60,137-026

AMENDMENTS TO THE DRAWINGS:

REPLACEMENT SHEET
 SERIAL NO. 09/864,809; FILING DATE: 5/24/2001
 SURGE SUPPRESSOR FOR A MIXER HEAD ASSEMBLY
 Applicant: Bellasalma; Attorney docket: 60,137-026

Fig-1B

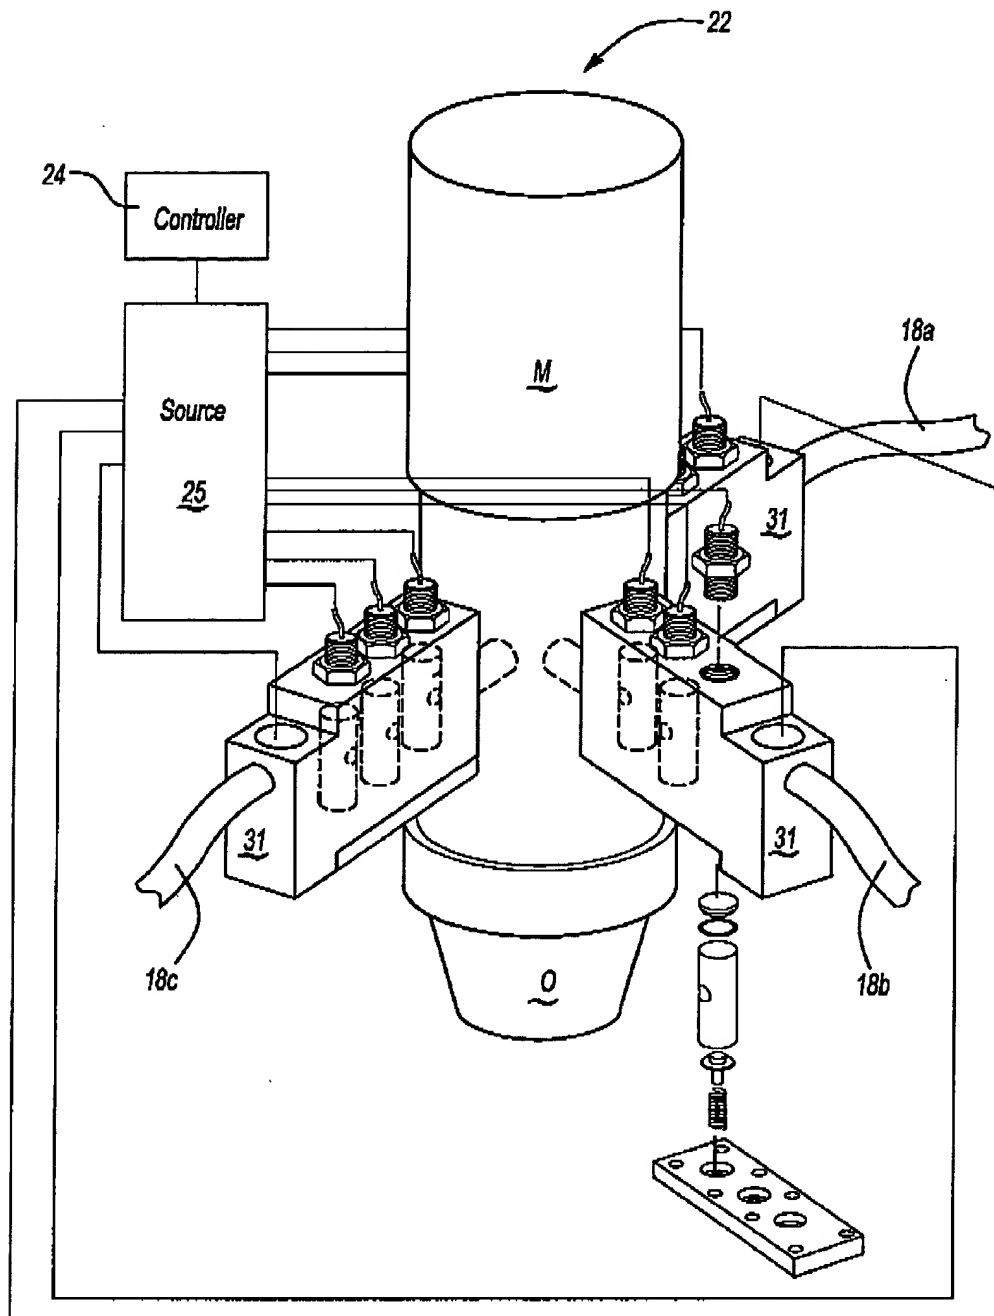
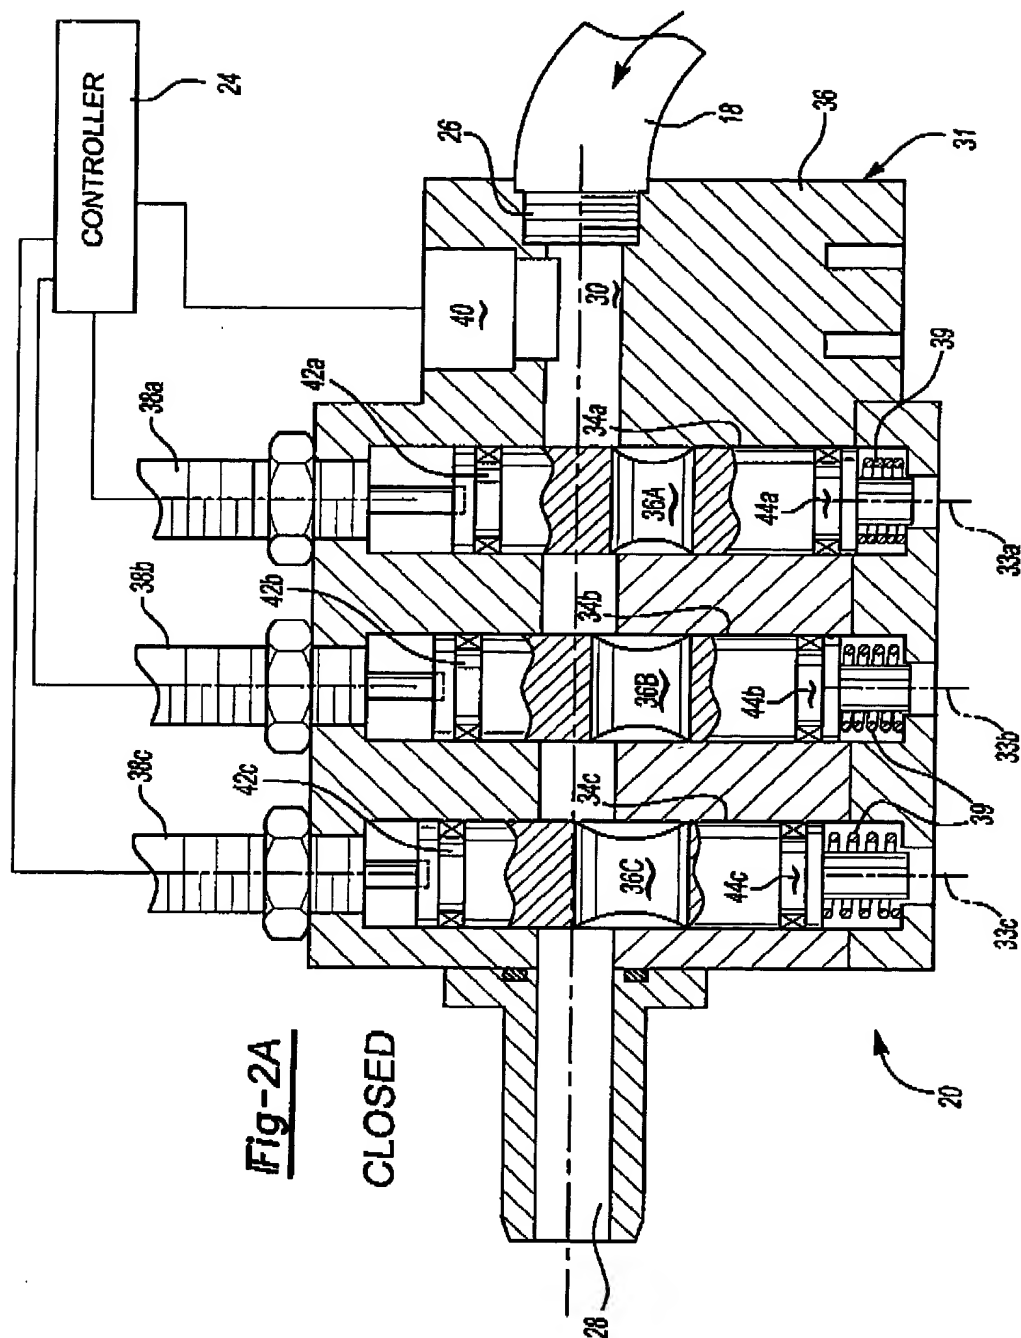
Figure 1B is resubmitted to formally incorporate previous drawing amendments.

Fig-2B

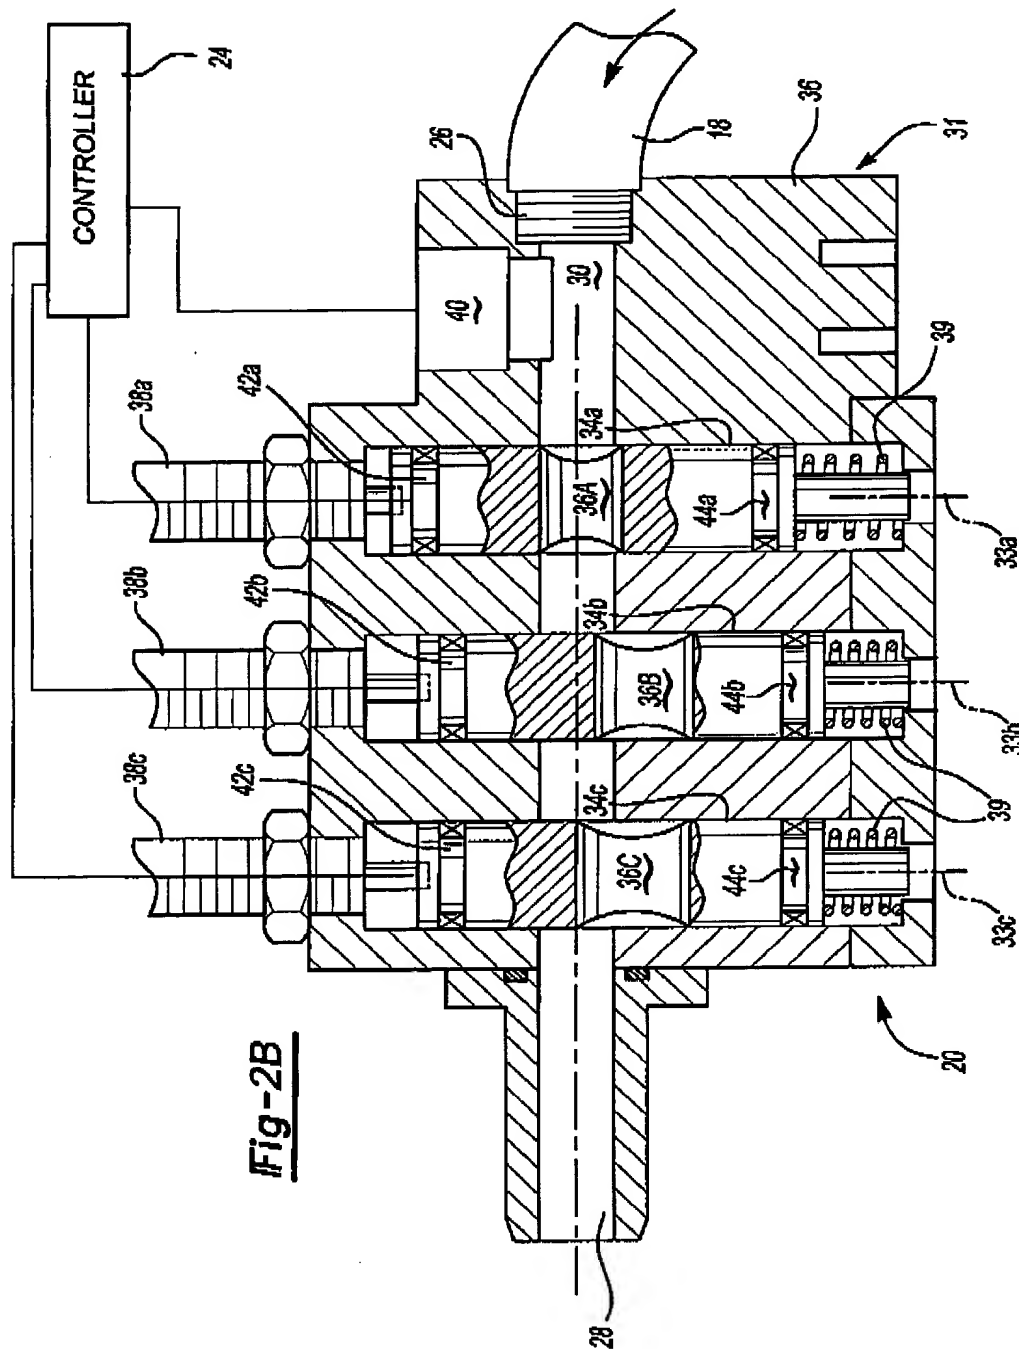
Figures 2A-2D are resubmitted to more clearly indicate that each sequential valve includes an opening larger than the previous valve. Paragraph [7]; claims 11 and 22; and Figure 3. No new matter has been added as such a construction is implicitly required to obtain the graph of Figure 3. Moreover, such a construction is described in paragraph [7] (although -- as noted by the Examiner - - may be somewhat contradicted elsewhere). Most importantly, claims 11 and 22 recite the inventive construction.
